SECTION ST

MODIFICATION NOTICE:

STEERING WHEEL AND STEERING COLUMN

SST013D

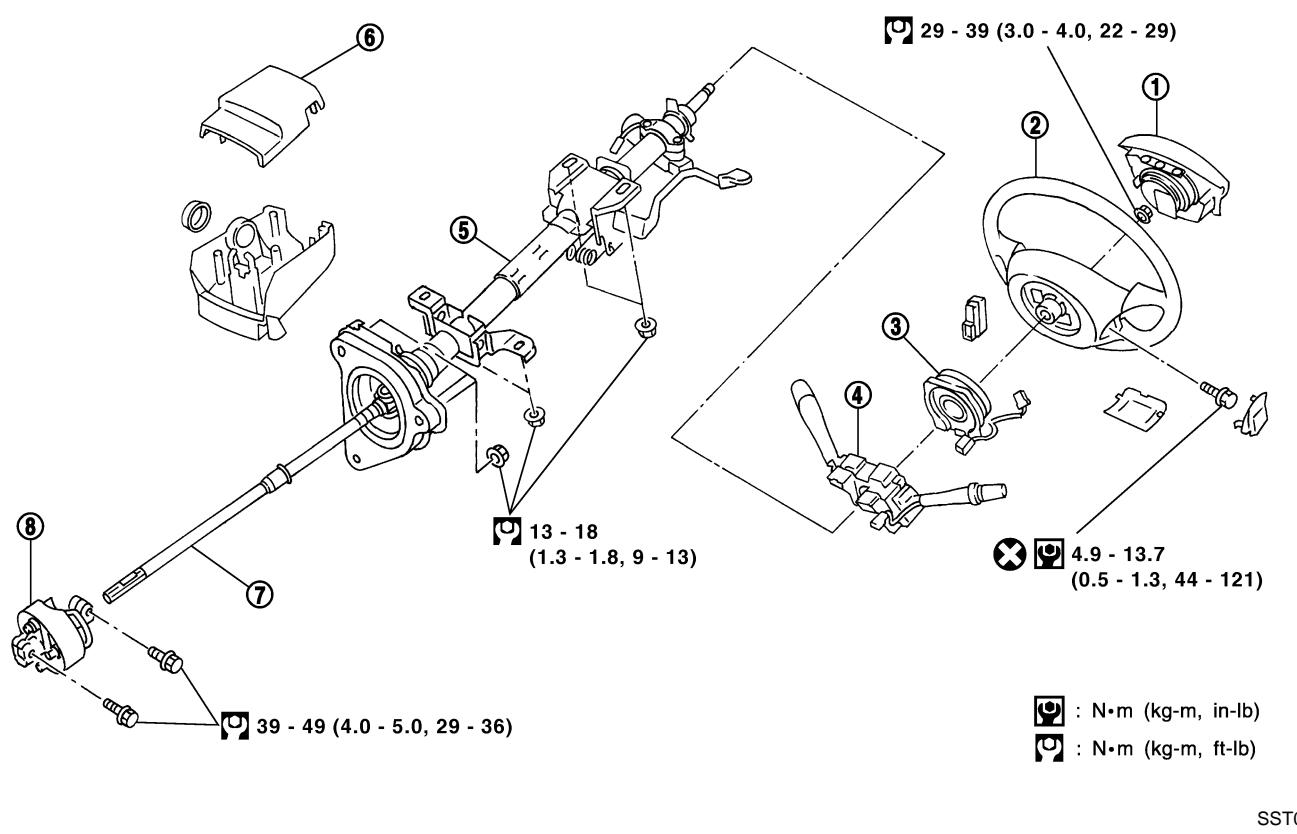
- Tightening torque for air bag module has been changed.
